# CITY PLANNING COMMISSION

- APPLICATION:**
- A. Negative Declaration
  - B. Special Permit for the construction of a six-story, 161,223 square foot office building
  - C. Special Permit to amend the PUD Guidelines to exceed the height limitations from 65 feet to 98 feet; and
  - D. Lot Line Adjustment to merge two, 4.8+ acre parcels into one parcel on 9.57+ acres in the Office Business (Planned Unit Development) (OB{PUD}) zone.

**APPLC. NO.**           P88-179           **MEETING DATE**           May 26, 1988           **ITEM NO.**           22

RE: **PRELIMINARY REVIEW - PARCELS 2 AND 3 - METROPOLITAN CENTER PUD - SOUTH  
NATOMAS - IR88-012**

CONCEPTUAL LANDSCAPE PLAN

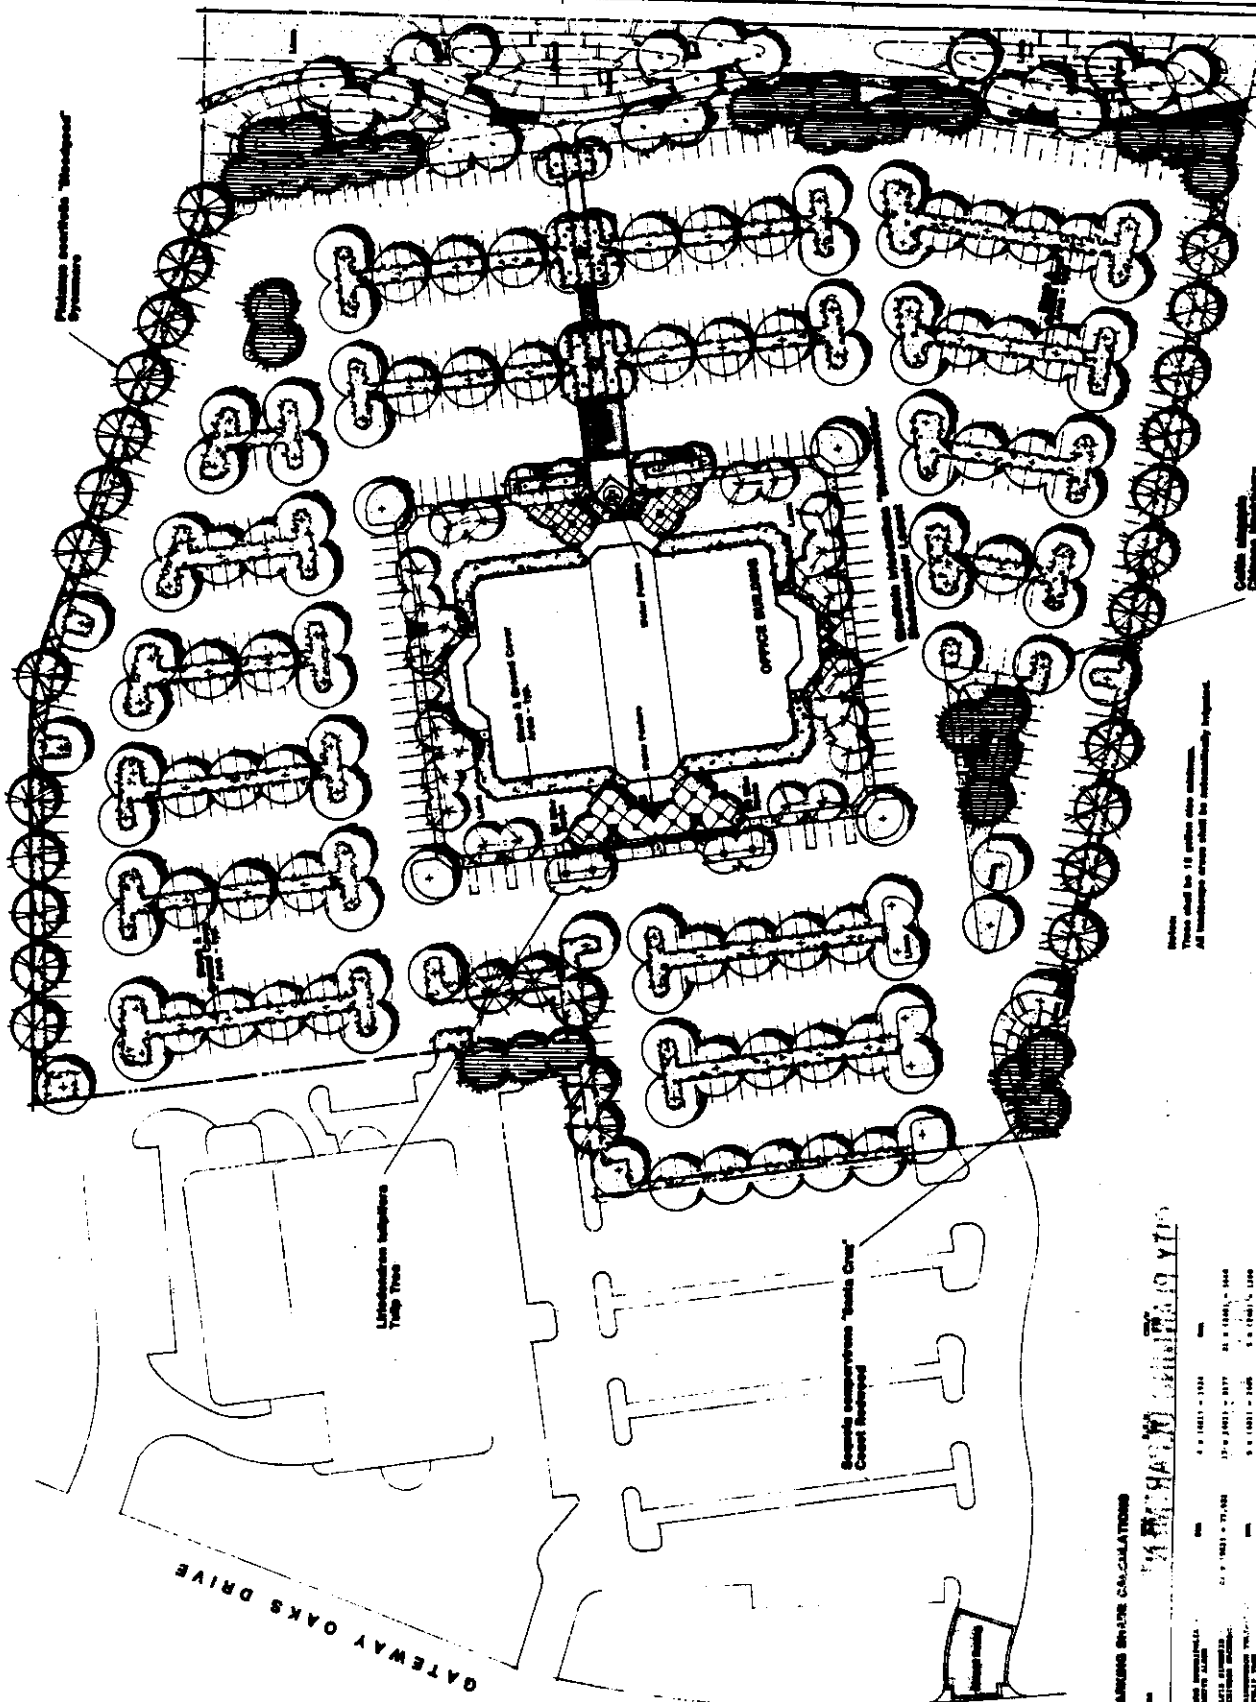
- B. Landscaping: The minimum landscape coverage for property within the PUD shall be 25 percent in the office zone. Landscaping within the I-5 scenic corridor does not count toward the minimum landscape coverage. The submitted landscape plan shall show the calculation for landscape coverage for the site. The landscape plan shall also specify that the pedestrian/bicycle walkway from the entrance and through the parking lot to the bike trail shall not be obstructed by landscape planters.

**SITE PLAN**

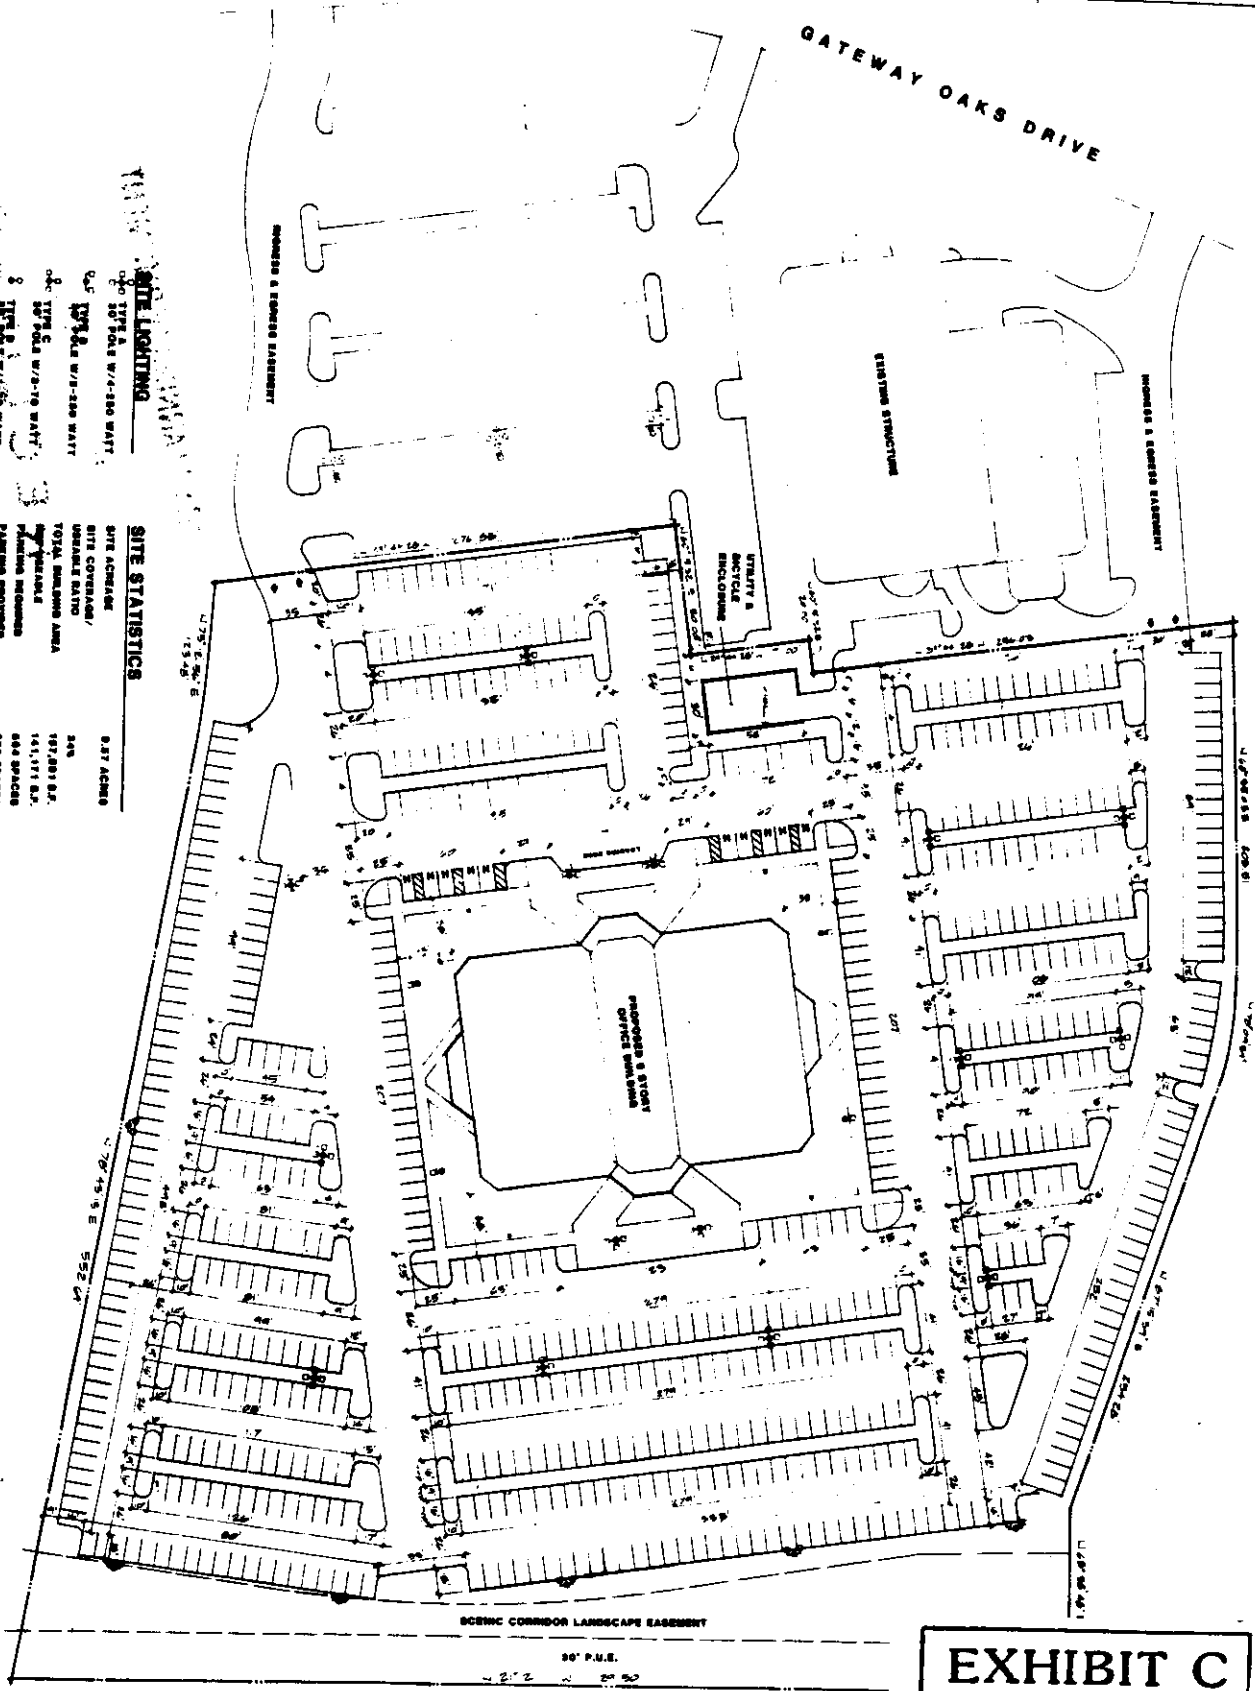
1. Relocate utility and bicycle enclosure to provide three entrances into parking facility.
2. Increase curve radius of concrete curbing at entrances of parking aisles.
3. Modify all access into parking aisles to 90 degrees with main driveway thoroughfares.
